SB TMG 601-1011 P1, Rev.2

SERVICE BULLETIN

Subject: Engine mount inspection - P/N 20-7120-H0037 03 only

Type affected: Cessna C172 (Reims F172) with
TAE 125-02-99 or TAE 125-02-114
as well as engine mount P/N 20-7120-H0037 03

Figure 1: Position Overview

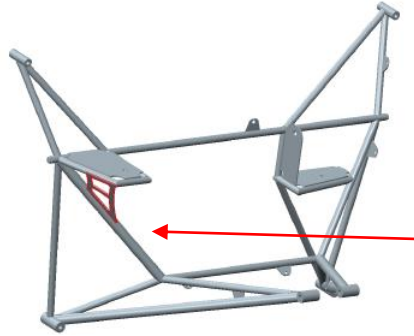
The bracket shown in figure 1 is generally welded on by one seam on the inner and outer side at each bracket end (4 seams in total). Each seam is a sectional welding, see figure 4 and 5. For the above listed engine mount serial numbers the red marked welding seams (inner side) shown in figure 2 resp. 4 are missing.

In addition to the engine mount inspection according to AMM-20-02 pay special attention to the outer welding seams shown in figure 5. Visually inspect the seams on cracks and check the bracket for deformation.
